ADDENDUM NUMBER THREE

10 November 2025

NC Department of Natural and Cultural Resources
Fort Fisher Aquarium – Renovation & Expansion
Phase 1
SCO ID #17-18042-02A

A-2.21 B

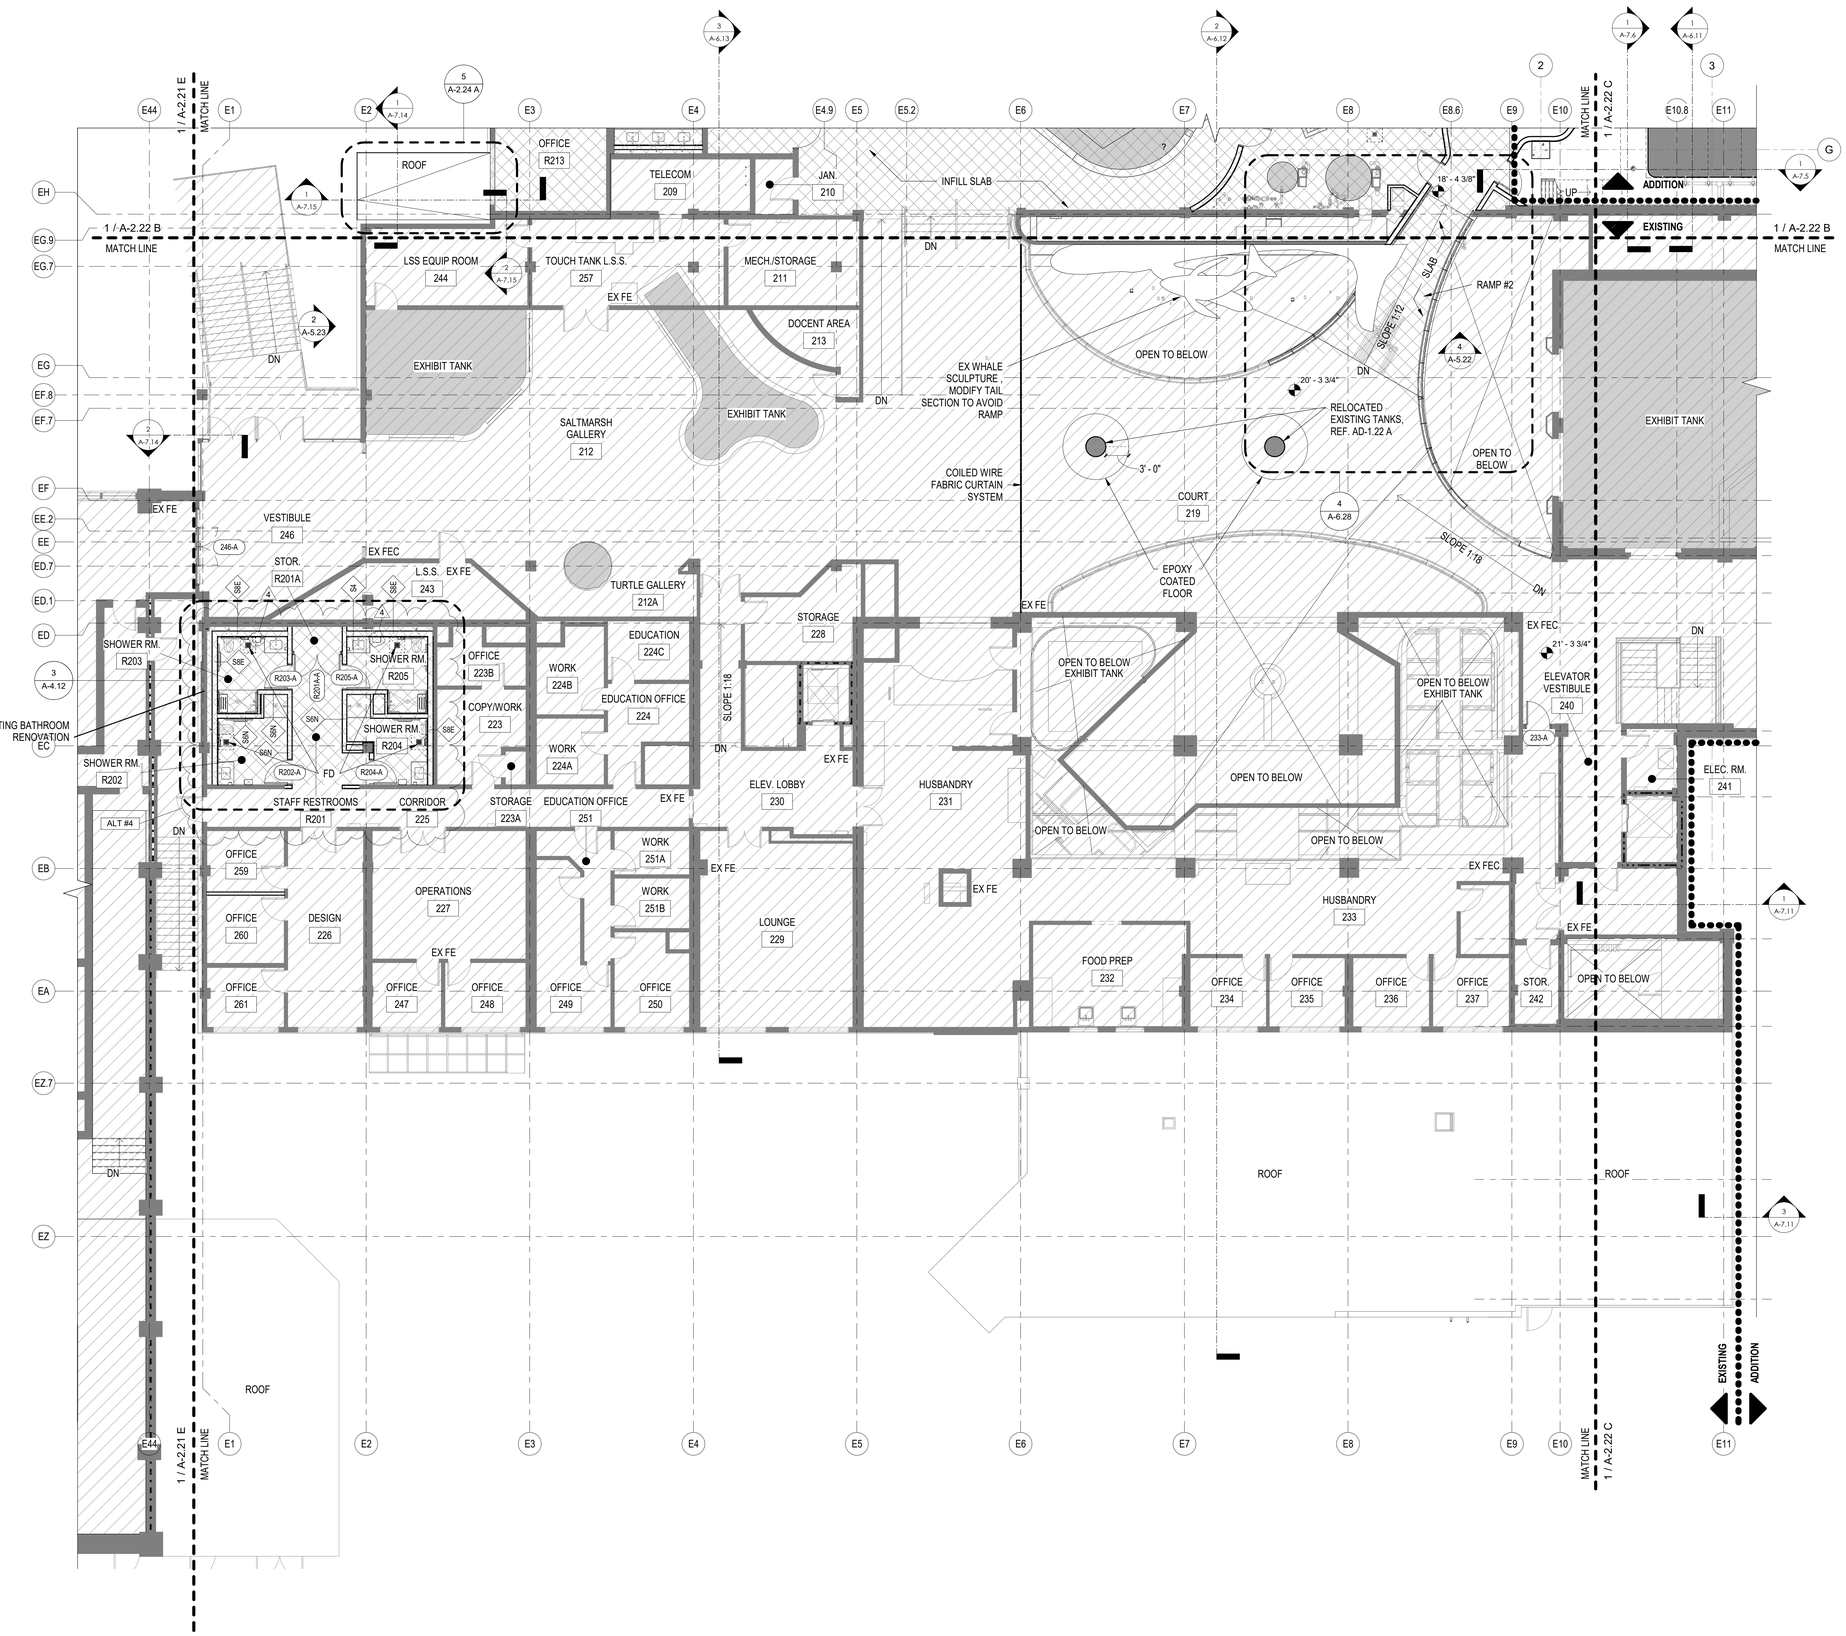
a. Updated demo notes.
6. A-2.21 B: FIRST FLOOR PLAN – TOUCH & SHARK TANK
    a. Added FRP grating at Pump Pit
    b. Moved Catering Kitchen refrigerator (NIC) and freezer (NIC) north 6”.

c. Door E108-A is now floodproof, barriers removed.
7. A-2.22 A: SECOND FLOOR PLAN – CAPE FEAR SHOALS
    a. Moved location of towel dispensers in staff showers.

LS3.23

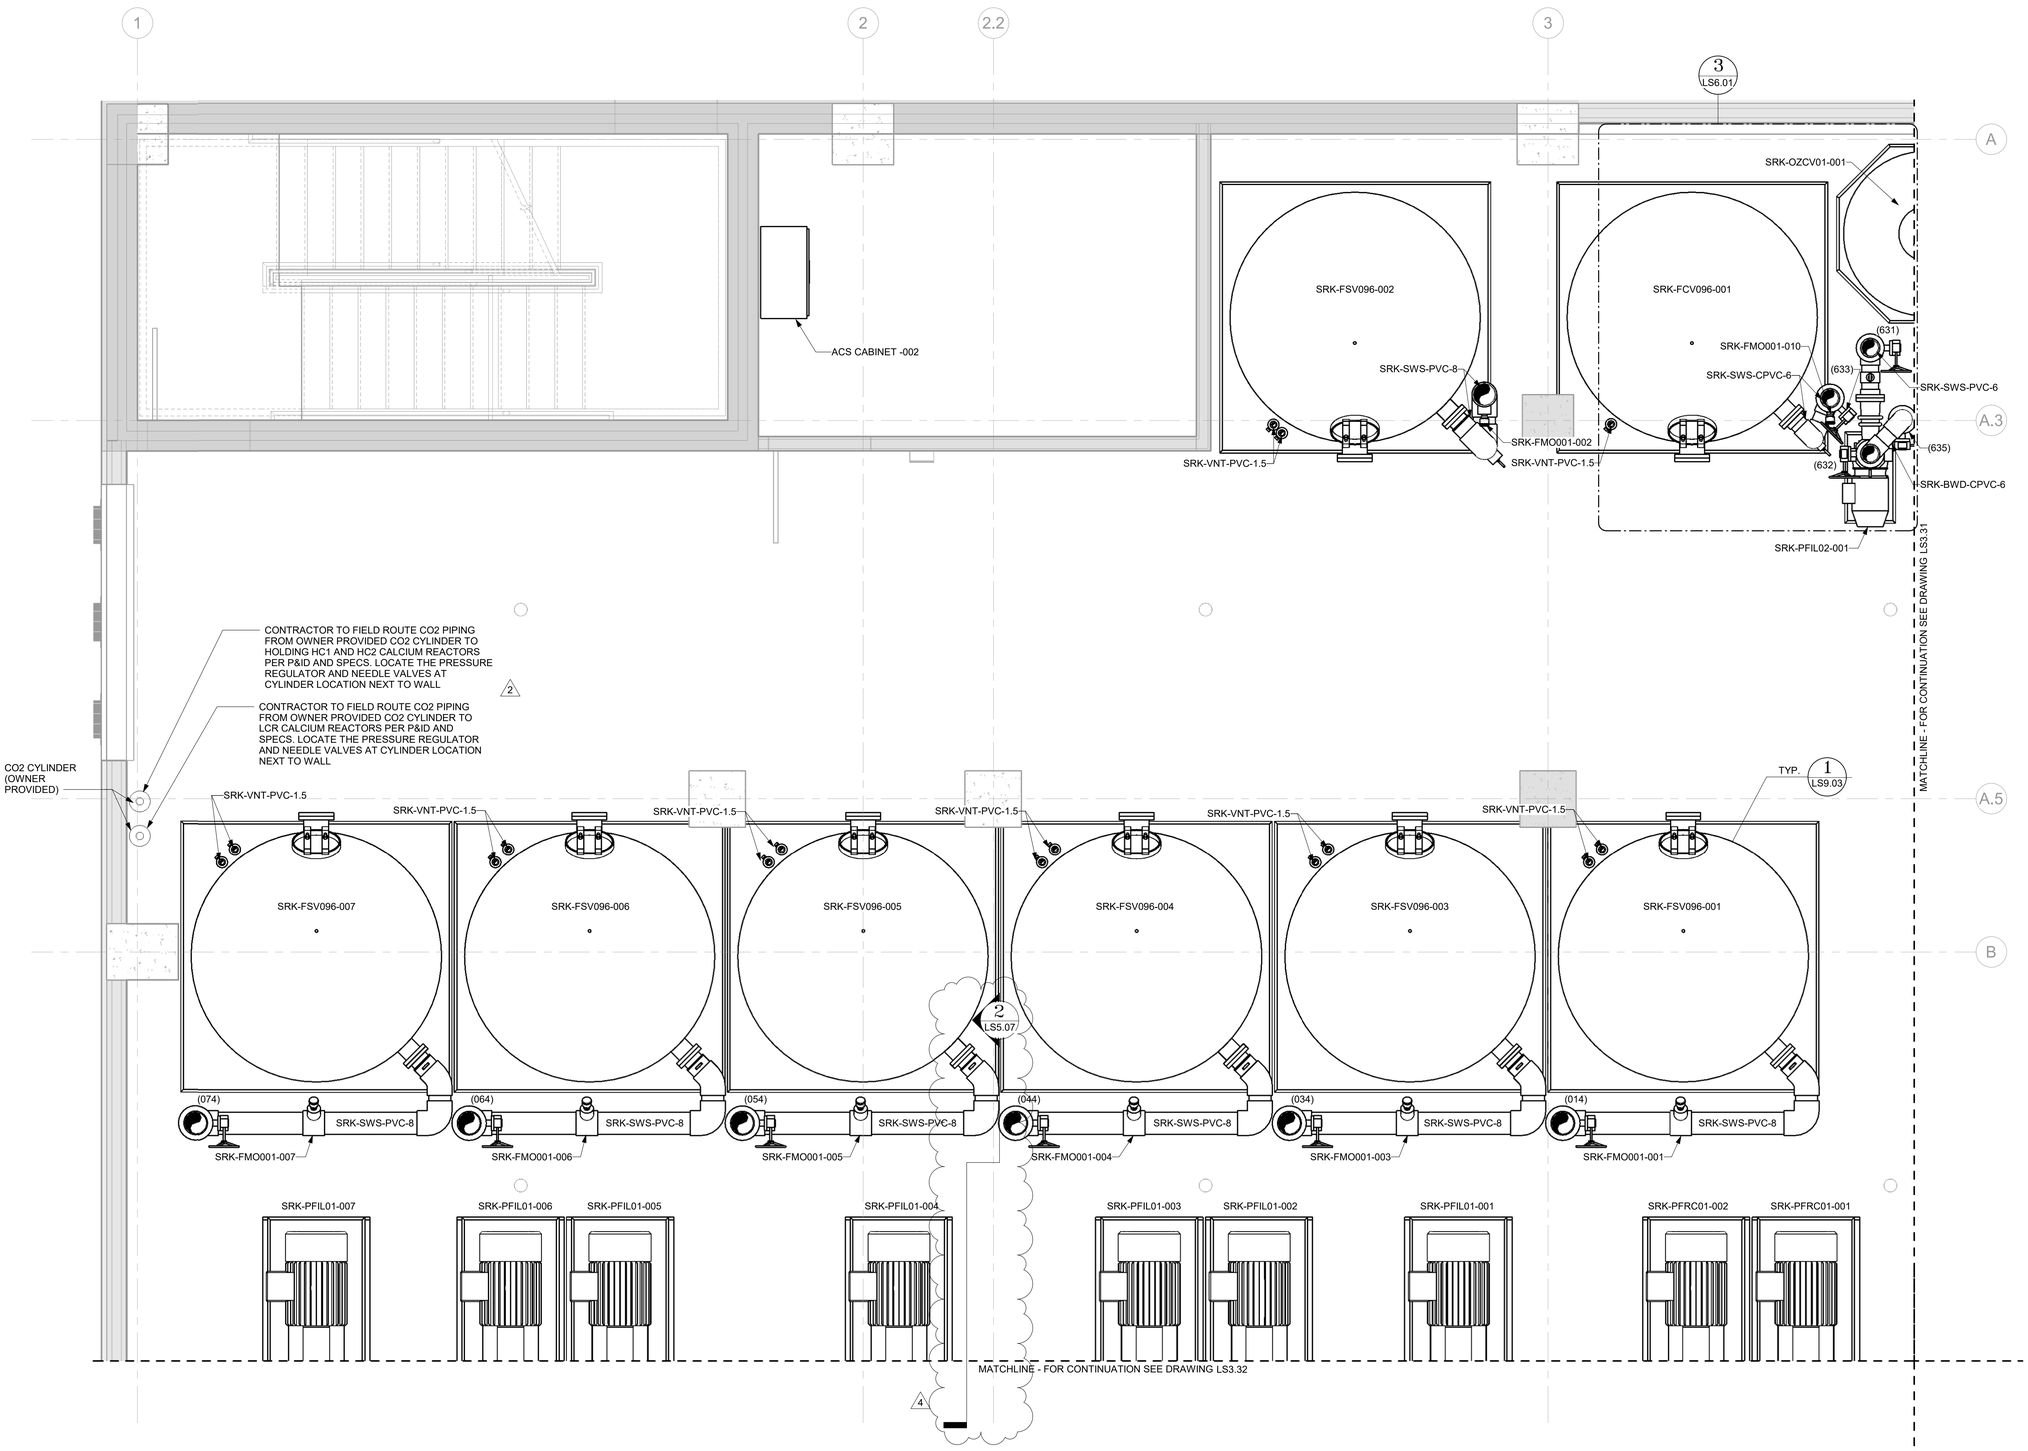
a. Changed portion of SMU HEX piping from CPVC to PVC to match P&ID for clarification
119. LS3.30: ENLARGED LSS PLAN - 1ST FLOOR - EL. 10.33' TO 18.33'

LS3.30

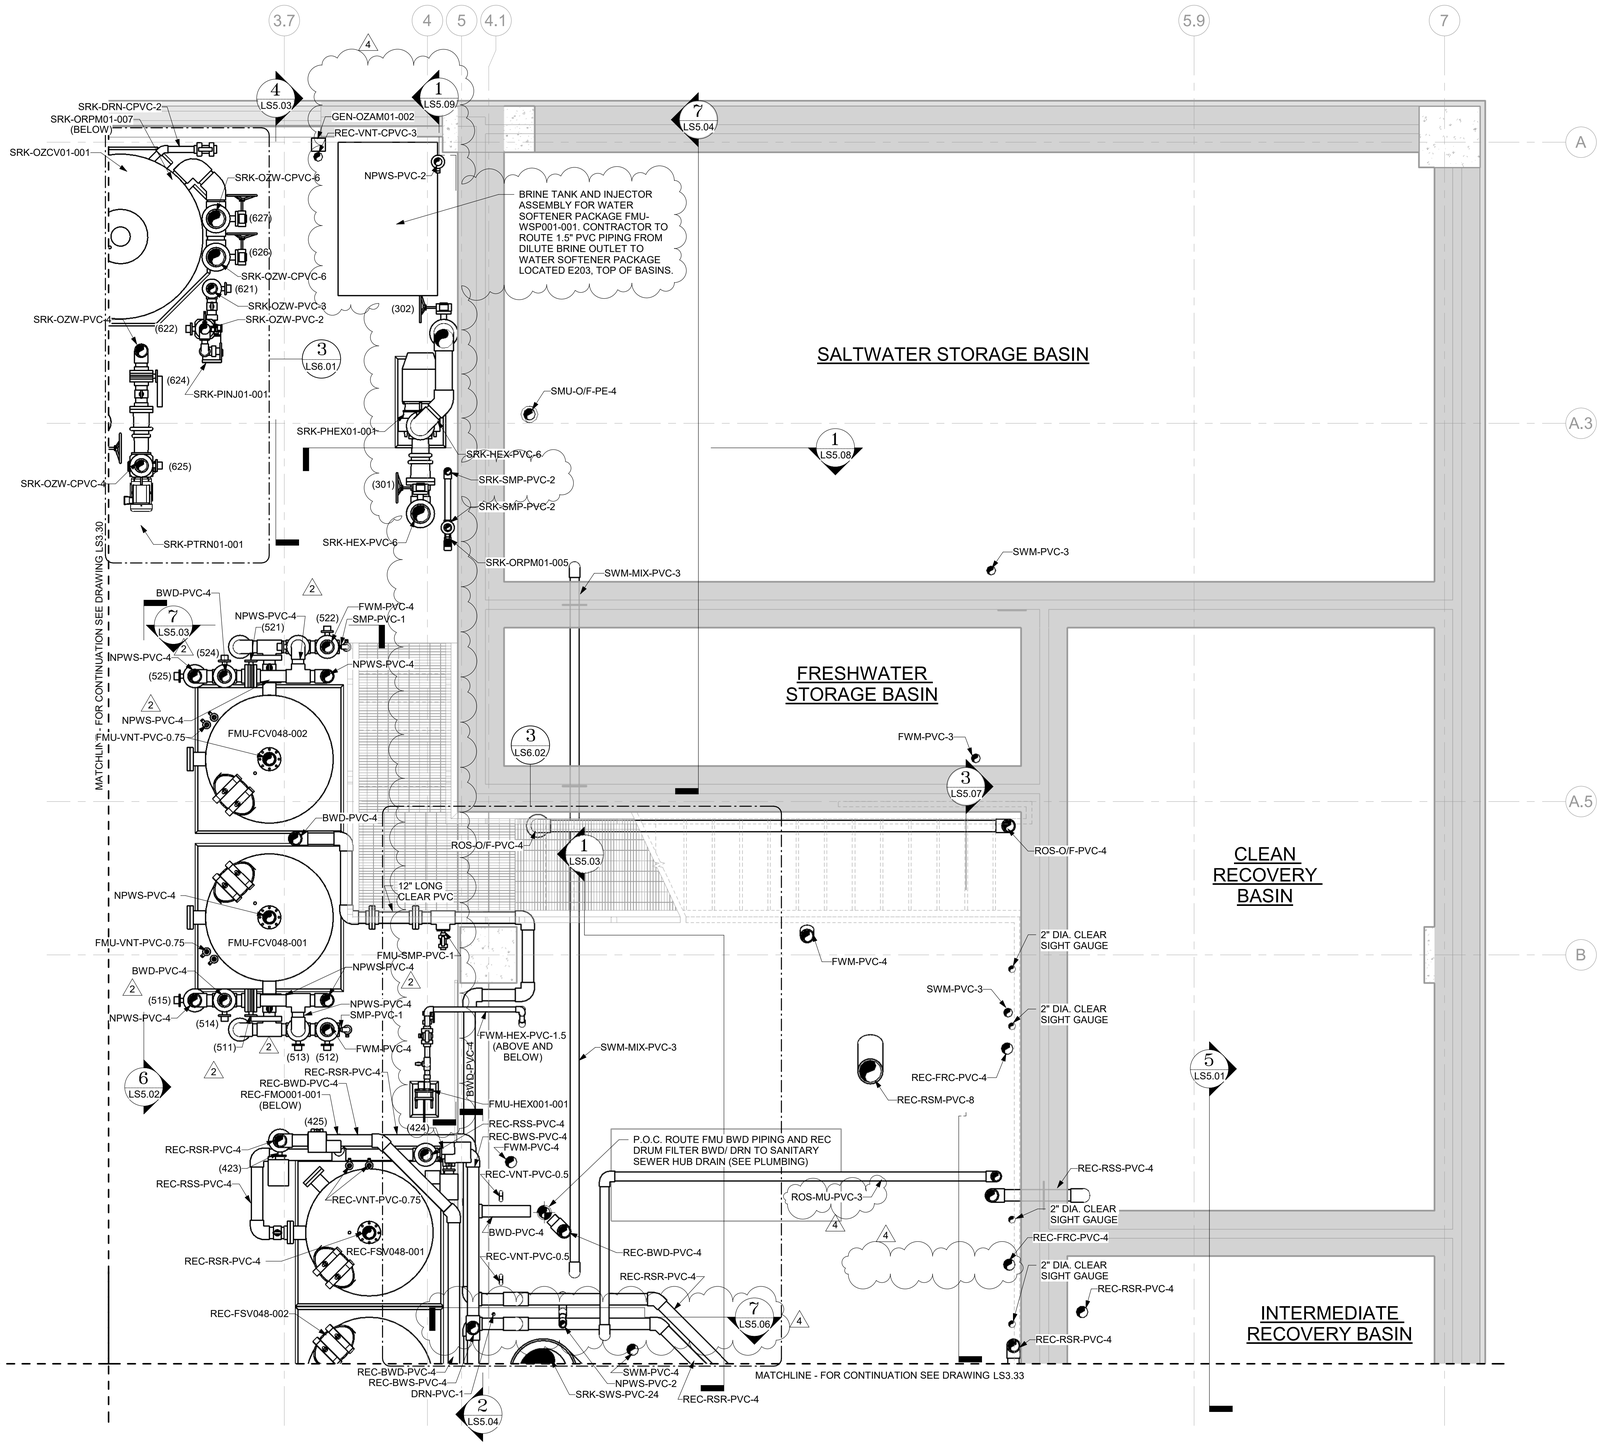
a. Added section 2/507 for clarification.
120. LS3.31: ENLARGED LSS PLAN - 1ST FLOOR - EL. 10.33' TO 18.33'
   a. Add pipe tag for clarification
   b. Added section 7/5.06 for clarification

LS3.32

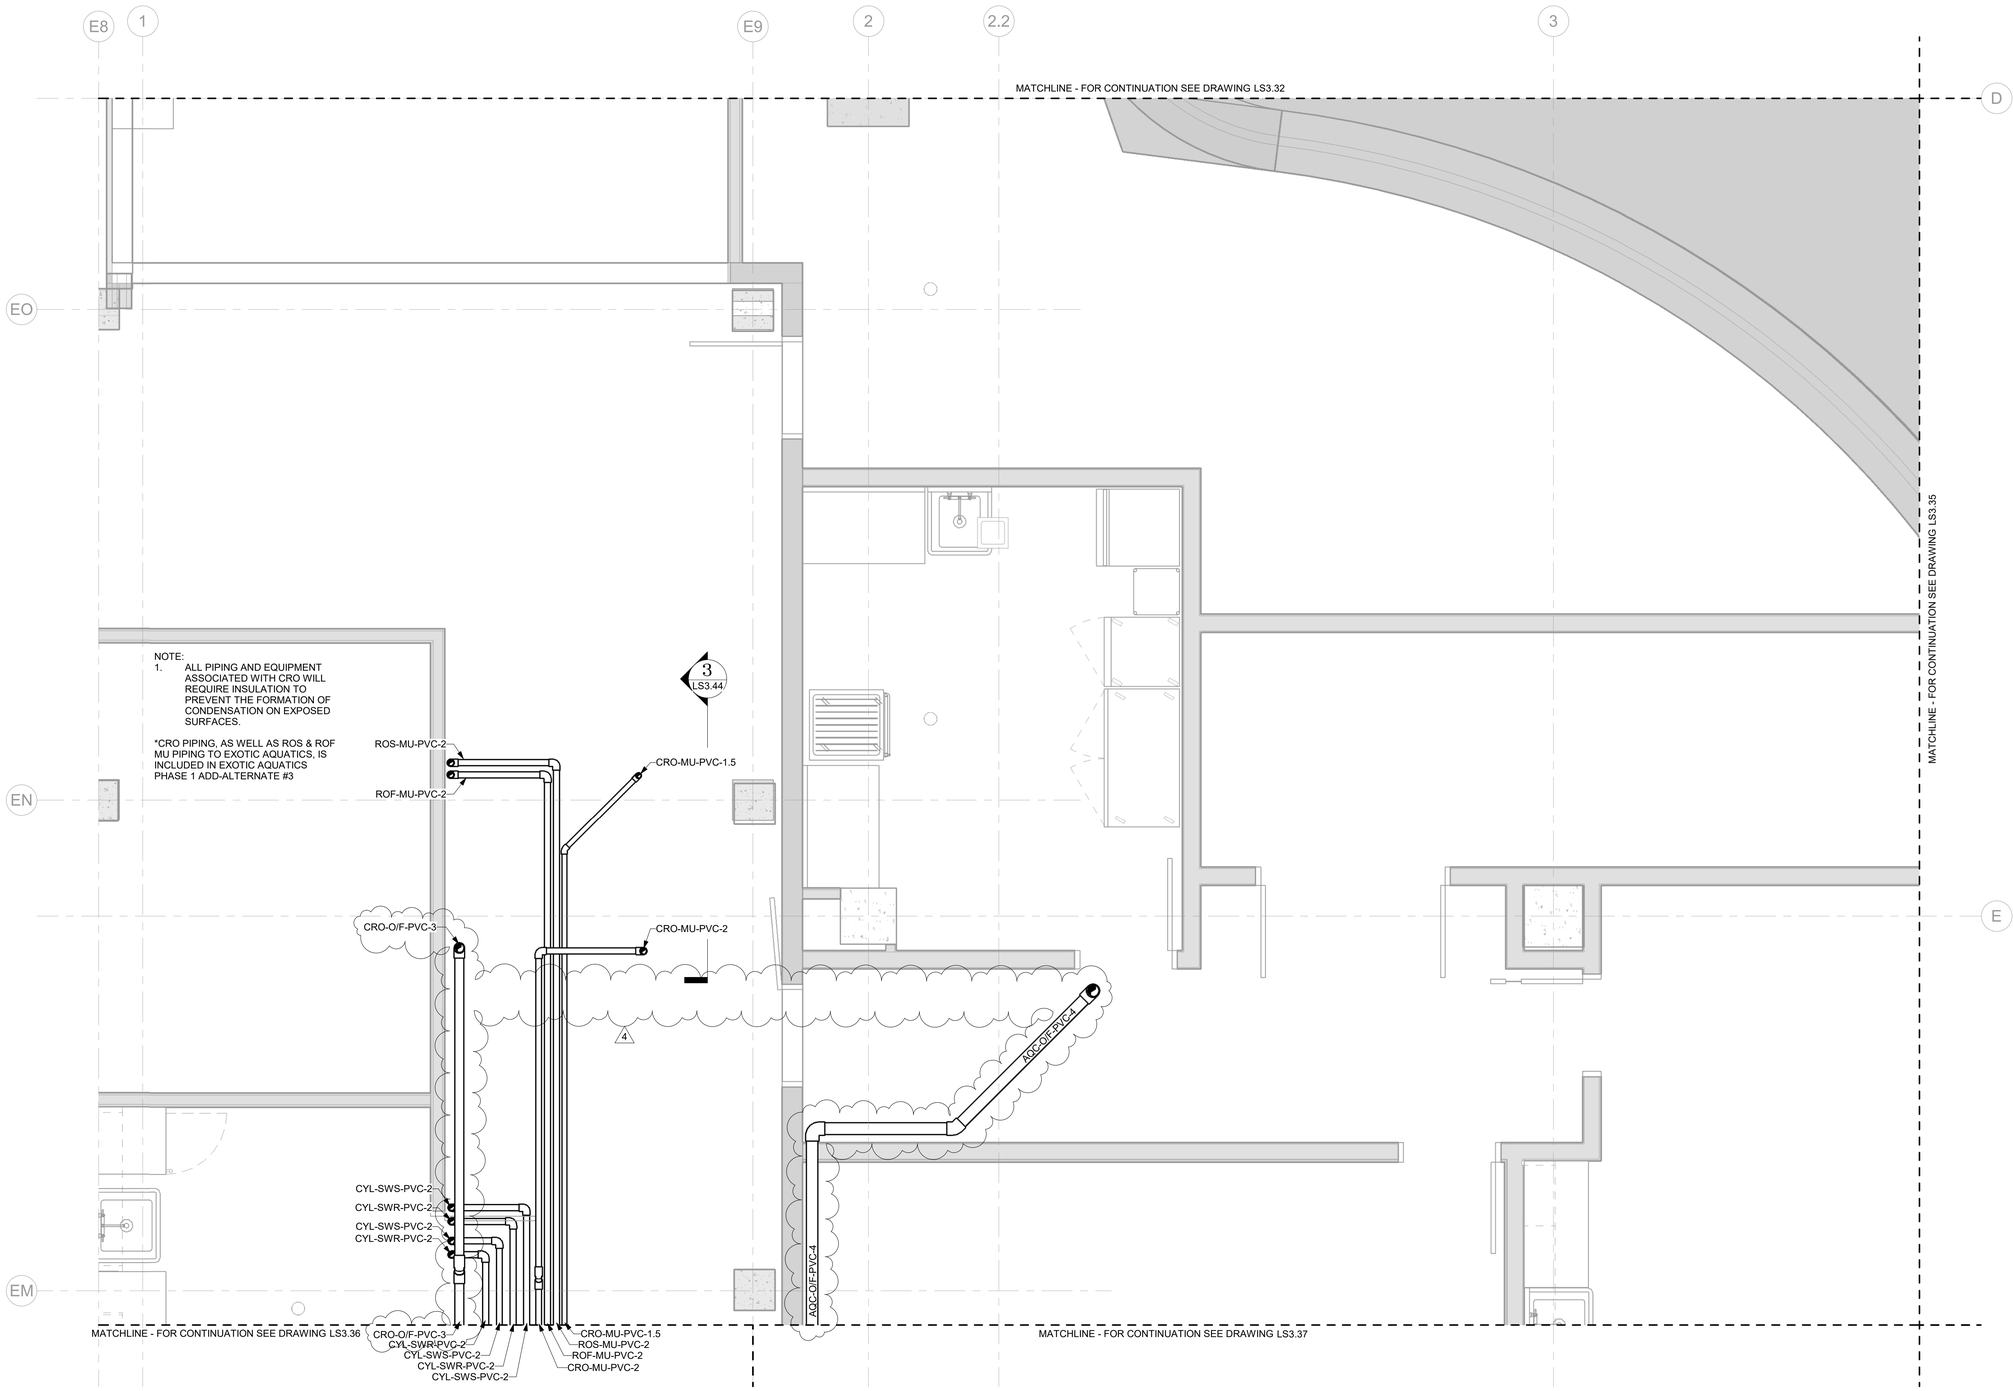
121. LS3.32: ENLARGED LSS PLAN - 1ST FLOOR - EL. 10.0' TO 18.33'
   a. Added section 2/507 for clarification.
122. LS3.34: ENLARGED LSS PLAN - 1ST FLOOR - EL. 9.08' TO 18.33'
